Wiltshire Council Planning Consultation Response

Application No: PL/2025/07191 - Knoll Farm, Norton Ferris, Warminster, BA12 7FG
Change of use of land and building for storage purposes (Class B8 Use) and General Industrial purposes (Class E Use) (Retrospective)

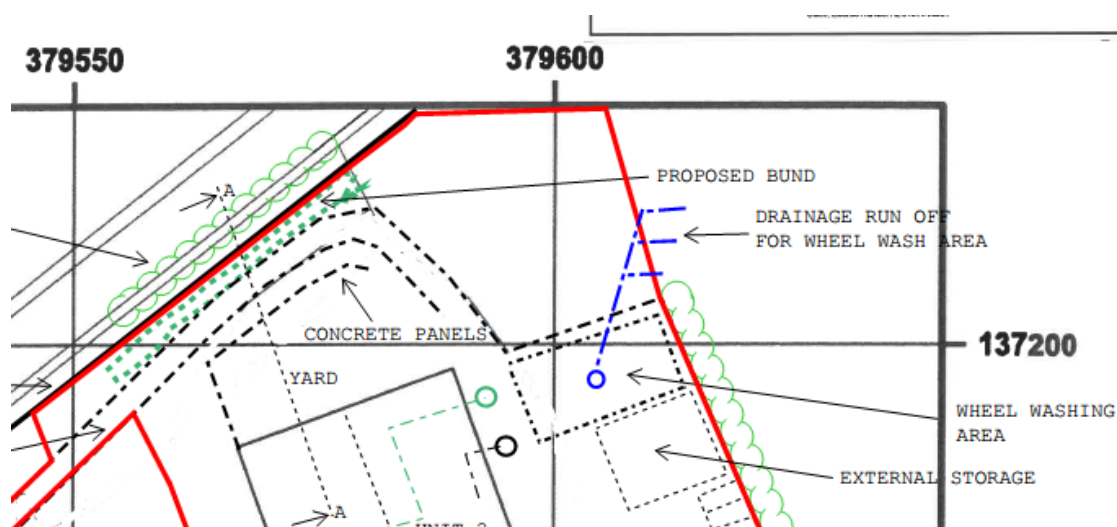
It is noted this planning application is titled 'retrospective', however in the Site Plan drawing, the bund is annotated as 'proposed'. The applicant should clarify which proposals have been installed, and which are yet to be constructed, but are proposed. This response is produced on the assumption all features have been constructed.

We note there are several comments from the public on the planning application portal relating to existing surface water flood risk on the highway and potential contamination of watercourses & groundwater. As part of this application, the applicant will have to demonstrate there is no increased flood risk to adjacent land, including the highway, and that any pollution risk to groundwater & watercourses is appropriately mitigated.

- a. The applicant must submit a surface water drainage strategy for the site. Any proposals should be designed in accordance with the Non-statutory Technical Standards for Sustainable Drainage Systems and the latest SuDS Manual (C753). The applicant is referred to the informatives for further details on the information required.
- b. It is noted the applicant is proposing, or has installed, a bund on the boundary of the highway and Knoll Farm. The applicant must provide the following information related to the bund:
 - i. The materials used to construct the bund
 - ii. Pre and post-development overland exceedance drawings for the 1 in 100+CC year event. The drawing must include flows from the highway, adjacent land and the farm itself.

- a. The applicant must outline the mitigation measures proposed to prevent hazardous materials polluting groundwater or adjacent watercourses.
- b. The applicant is proposing, or has installed, a drainage run off for wheel wash area that is directed offsite and discharges into the adjacent land. The applicant must outline the treatment proposed to prevent polluting the adjacent land.

- c. The applicant must outline how pollution will be mitigated in the event of a 'spill incident'.
